ADDENDUM No. 1

PROJECT NAME: Alamodome Boiler Replacement

PROJECT NO: 45-00052

SHEET NO.
M1.1

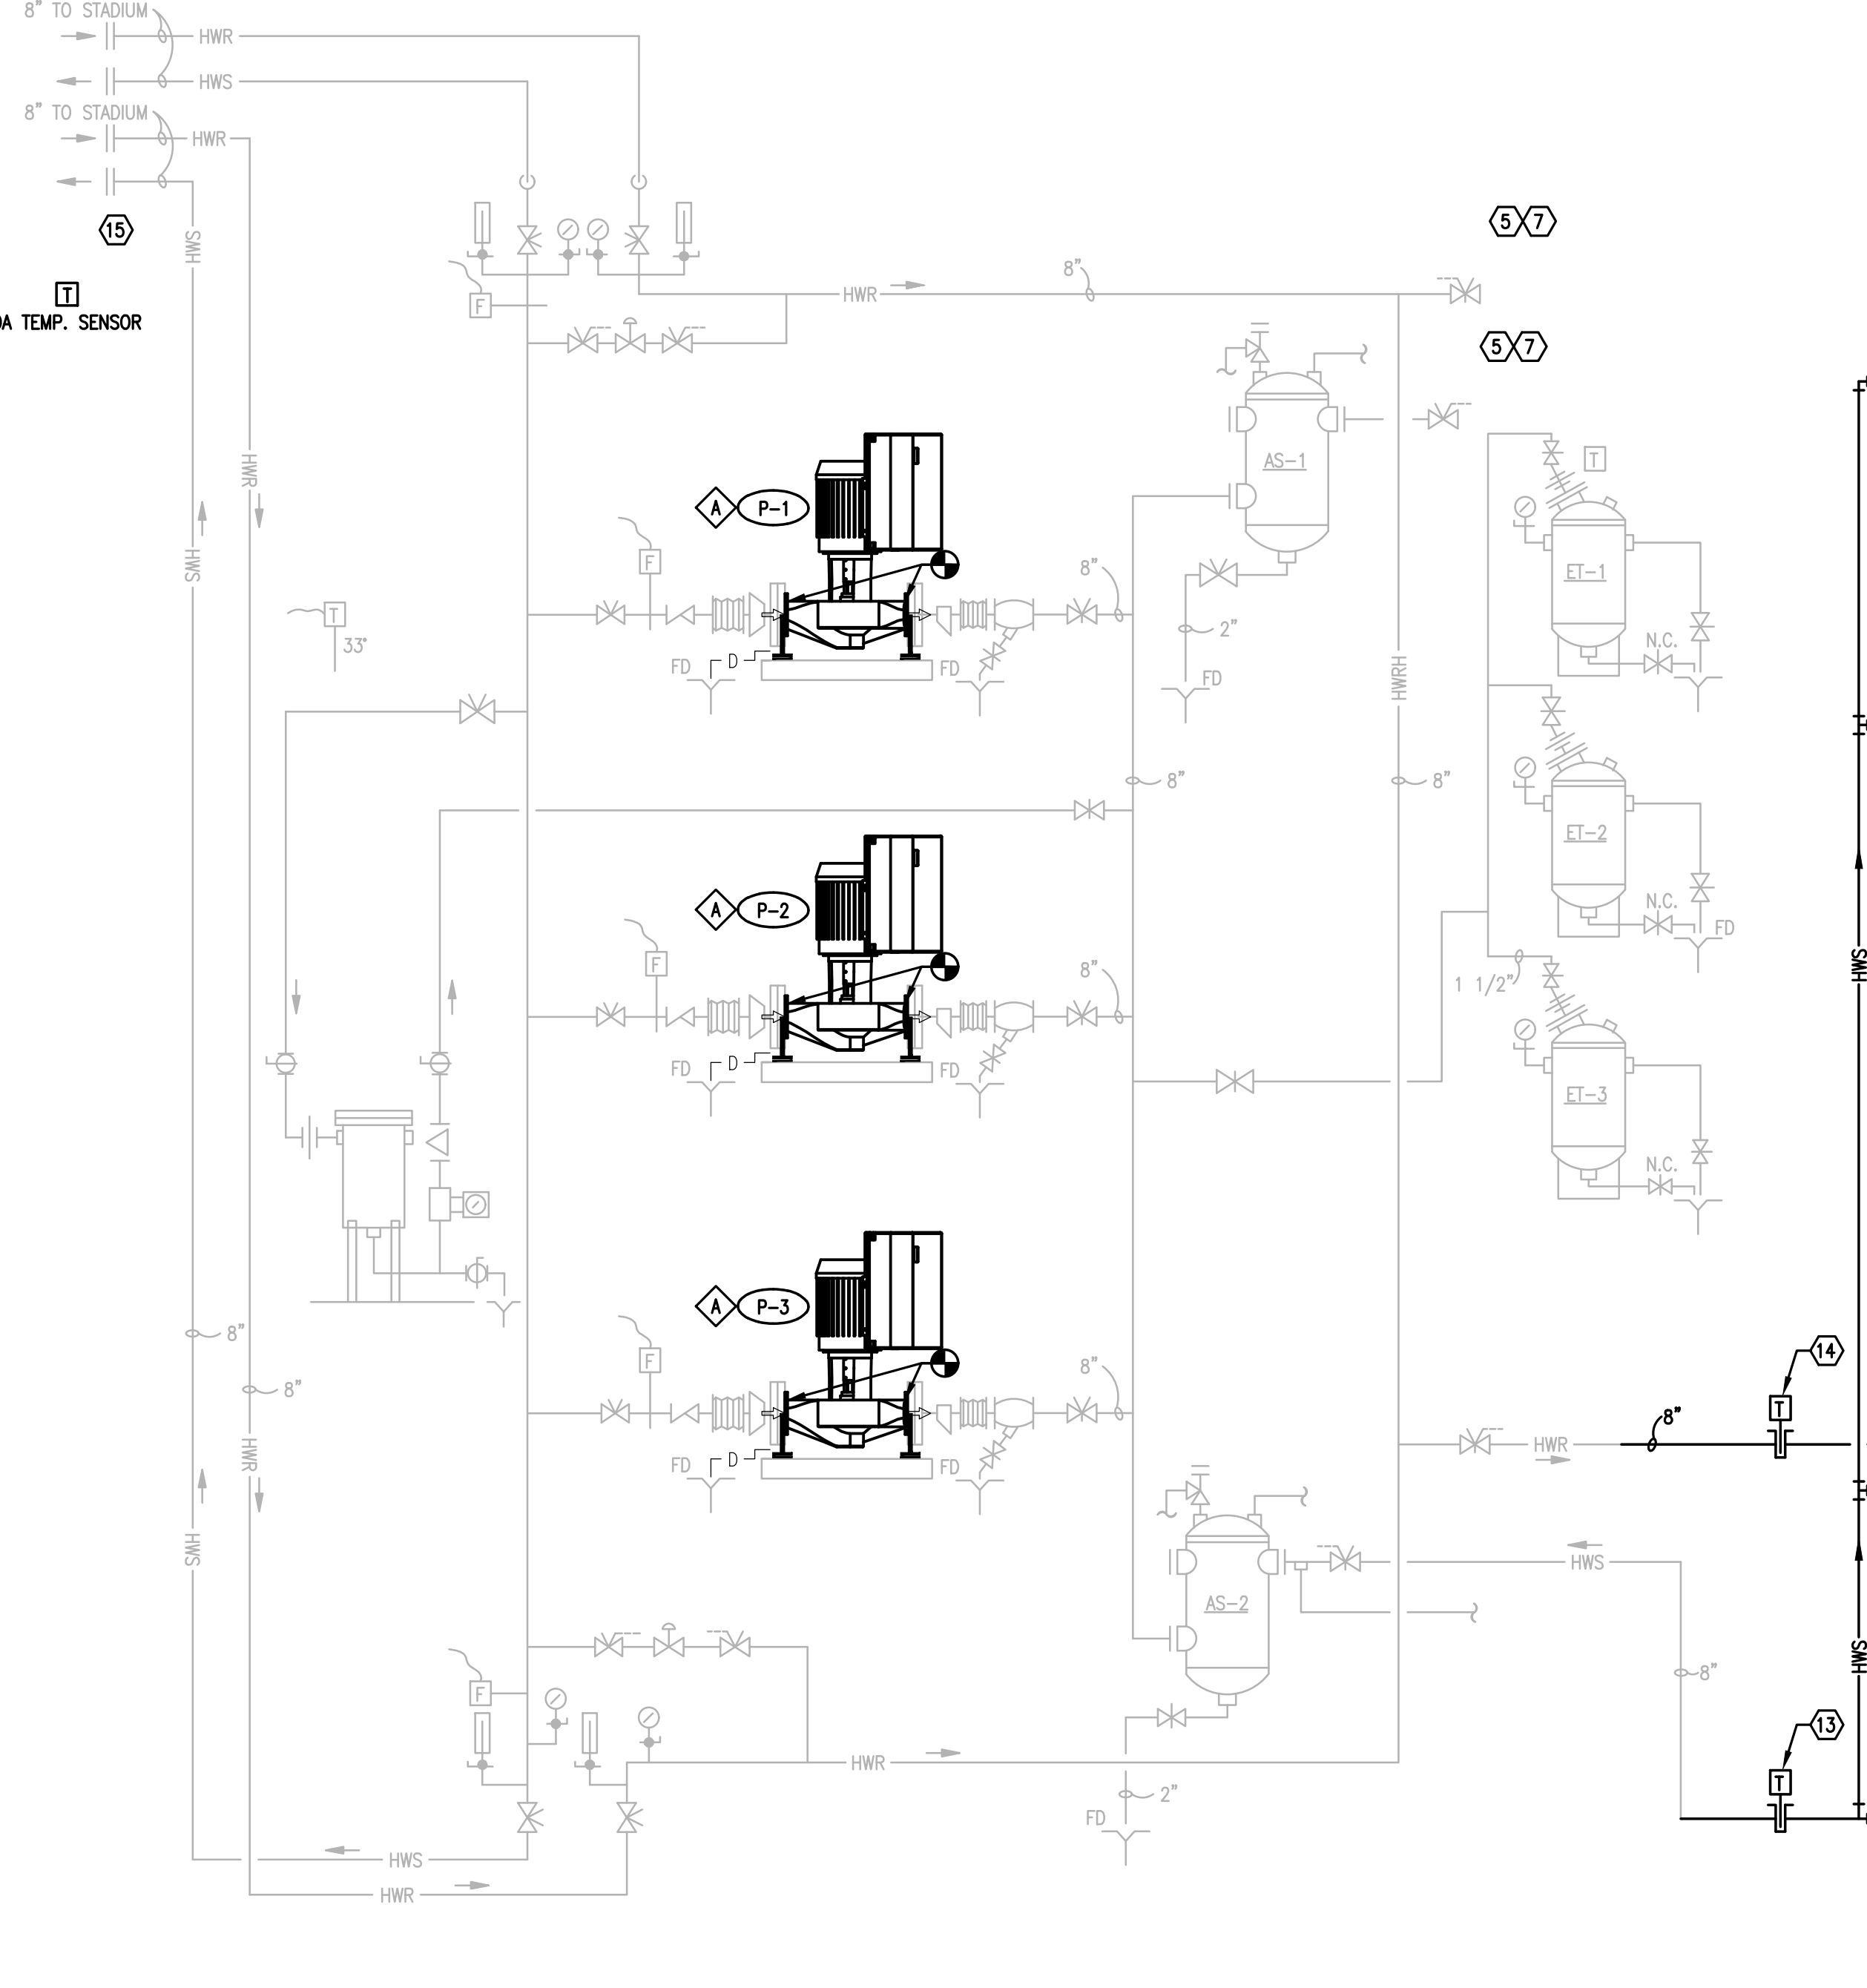
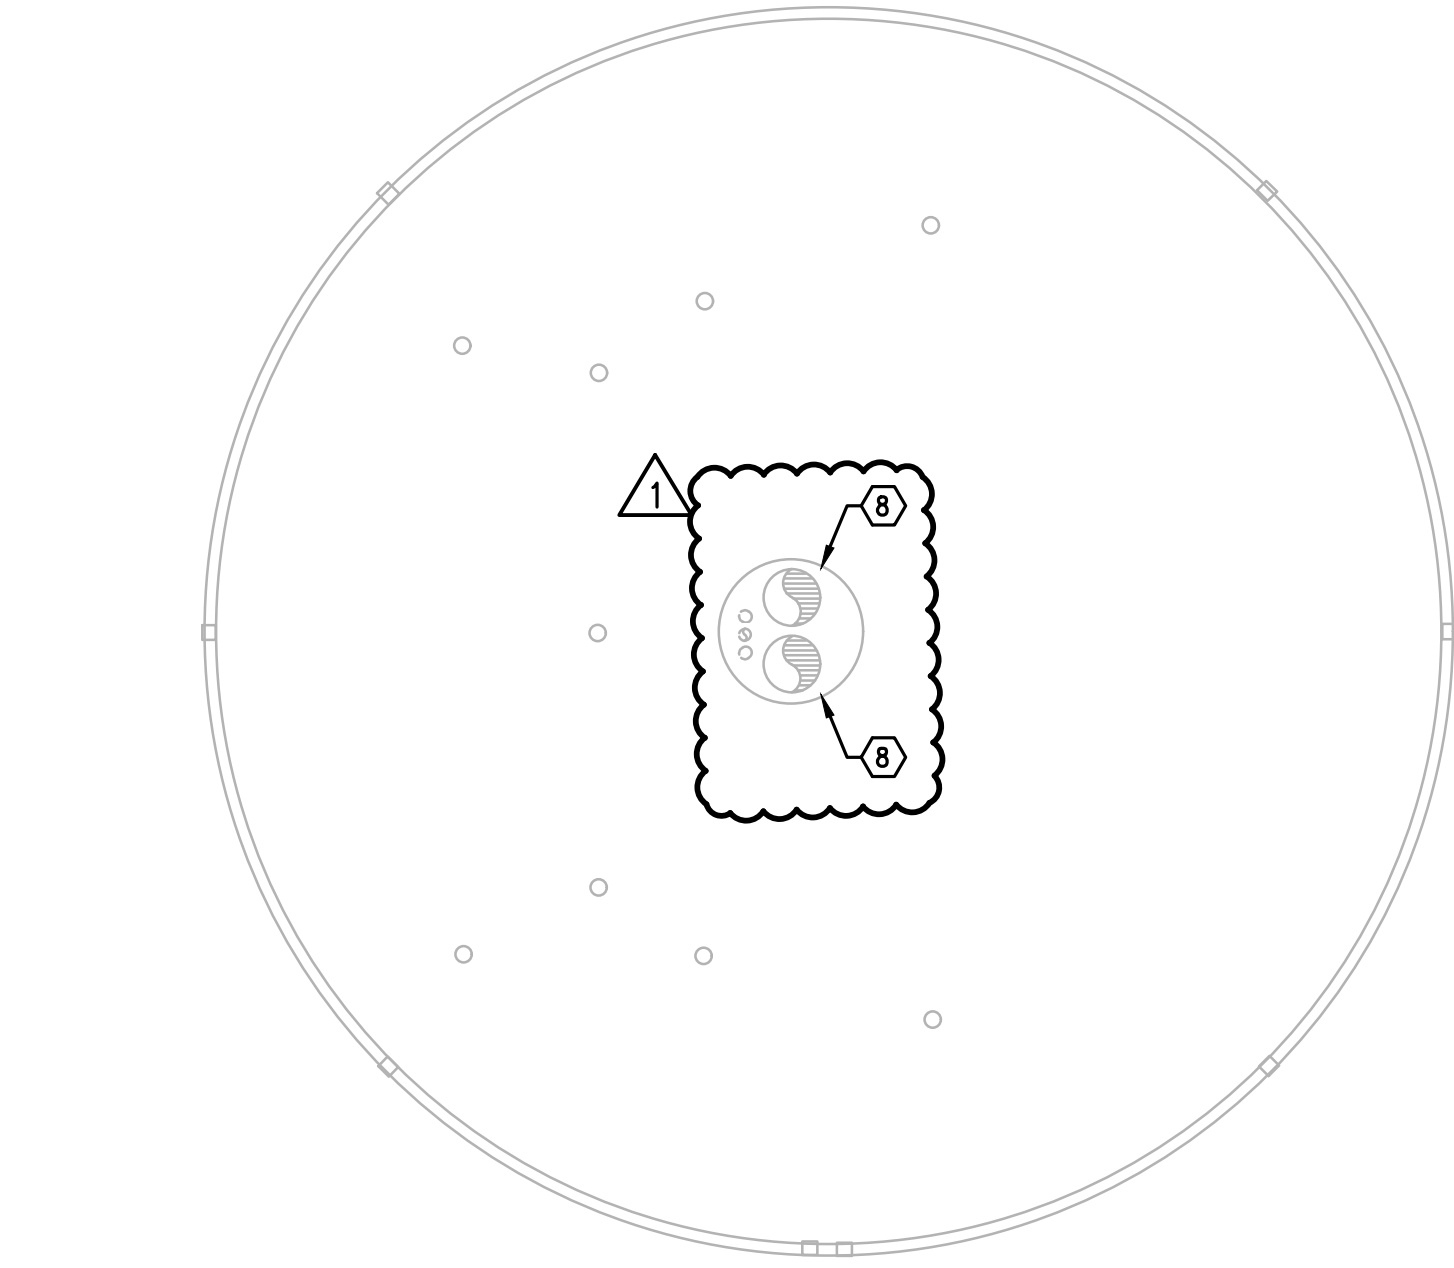
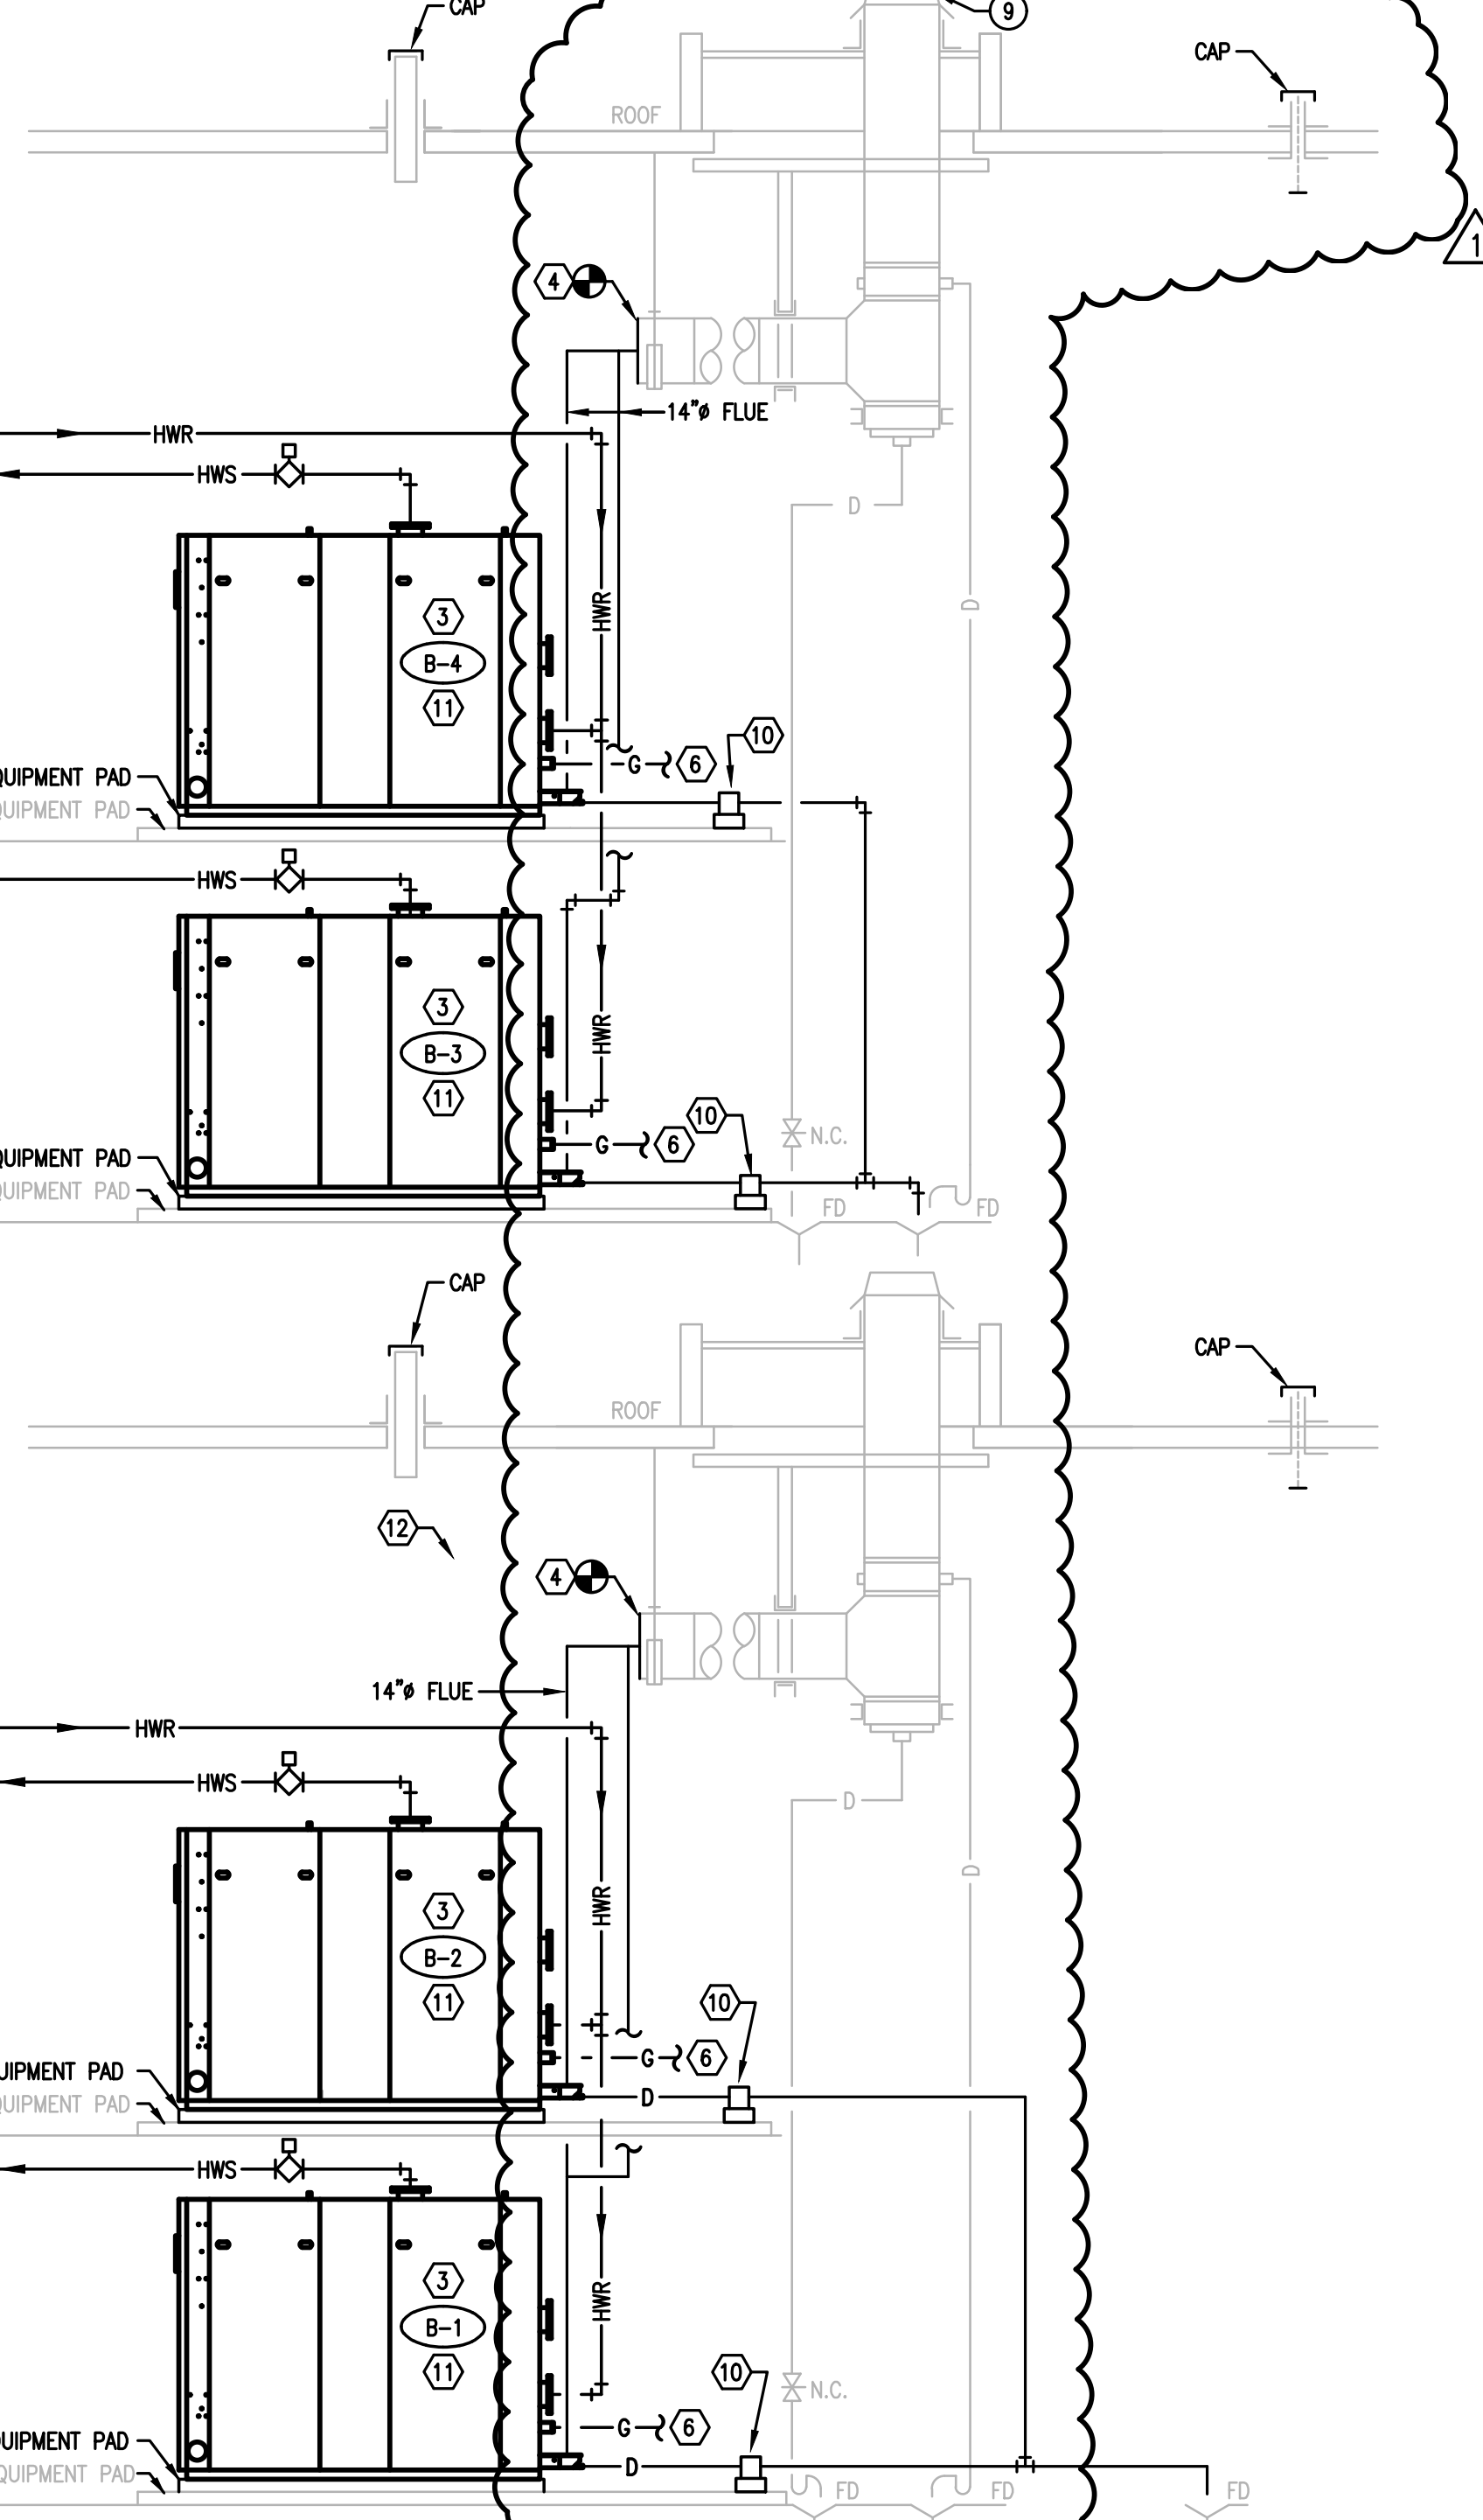
1. SHEET MD1.1 – REVISE DELMOLITION EXTENT OF EXISTING BOILER FLUE.
2. SHEET M1.1 – REVISE BOILER FLUE CONFIGURATION.

3. PLEASE PROVIDE THE ROOFING / STRUCTURAL REQUIREMENTS FOR THE NEW FLUE PIPE ROOF PENETRATIONS ON THE BOILER ROOM. SHEET M1.1 DETAIL 3 APPEARS TO HAVE A FLUE PENETRATION DOG HOUSE THAT MAY REQUIRE SOME TYPE OF WEATHERPROOFING. GOOGLE EARTH APPEARS TO SHOW A FLAT ROOF PENETRATION W/ WEATHERPROOFED FLUE PIPE. PLEASE PROVIDE CLARIFICATION.

RESPONSE: REFER TO REVISED DRAWINGS IN ADDENDUM NO.1, EXISTING FLUES TO BE REUSED. NO ROOF WORK REQUIRED.

5. AS DISCUSSED ON SITE, IT IS UNDERSTOOD THAT A NEW 6" CONCRETE PAD WILL BE Poured ON TOP OF THE EXISTING 4" BOILER PAD. PLEASE CONFIRM.

RESPONSE: REFER TO DETAIL NOTATIONS ON FLOW DIAGRAM 3/M1.1. CONFIRMED.
